SUBJECT: Significant hazards evaluation for FH/FQ proposed amend to  
 Licenses DPR-31 & DPR-41 dtd 830819.

Re: Turkey Point Units 3 & 4  
Docket Nos. 50-250 & 50-251  
Proposed License Amendment  
F<sub>Δ</sub>H/F<sub>Q</sub>

## Significant Hazards Evaluation

#### Turkey Point Units 3 & 4

Figure 3.2-3

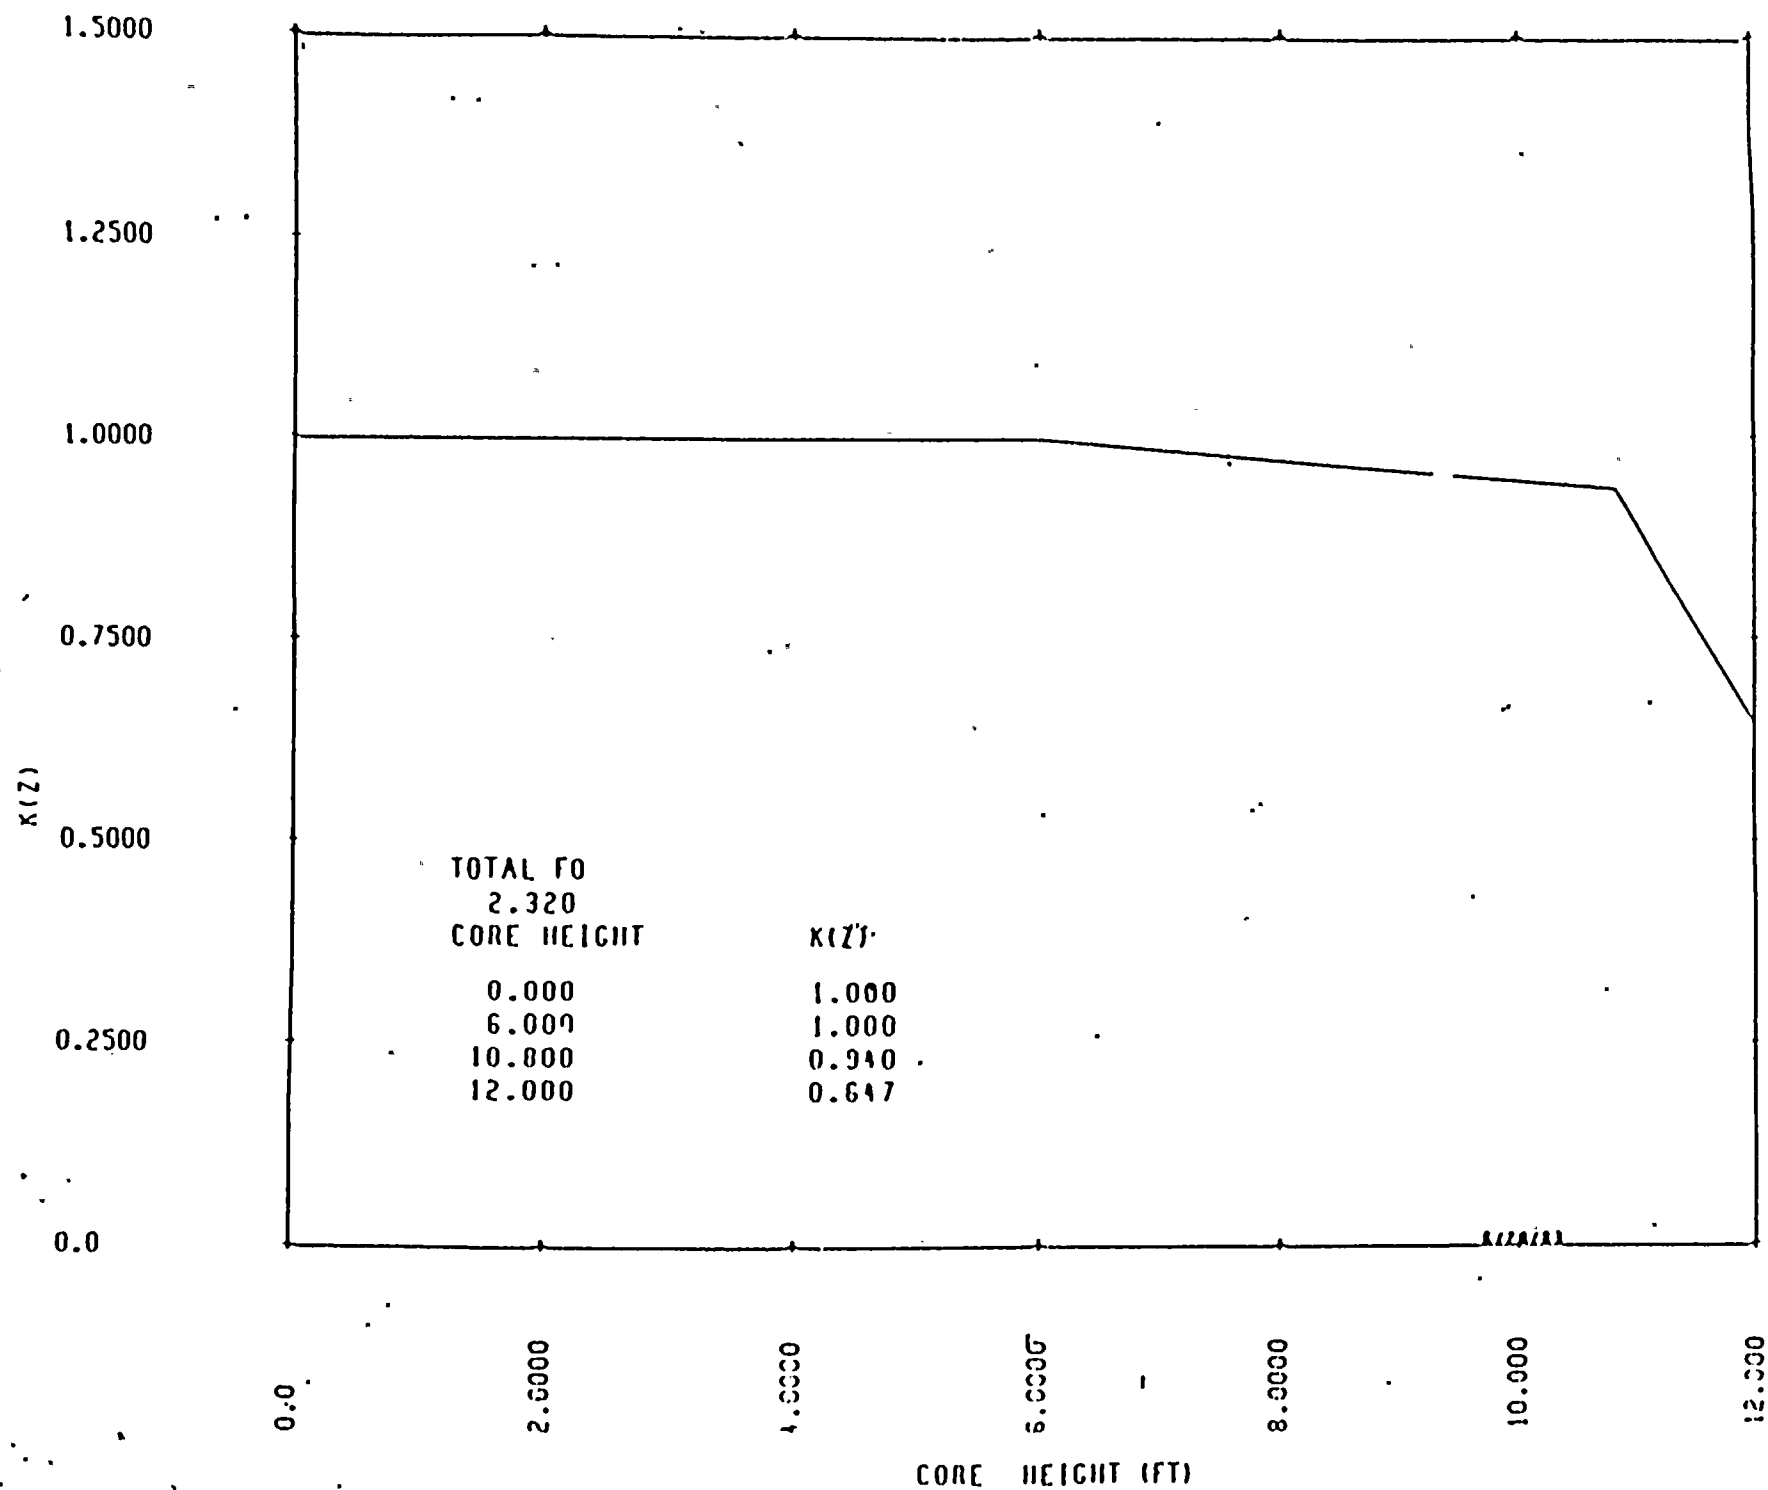
List of Figures  
Page 2.3-3  
Figure 3.2-3  
Page B2.1-2

Replace page  
Replace page  
Replace page  
Replace page
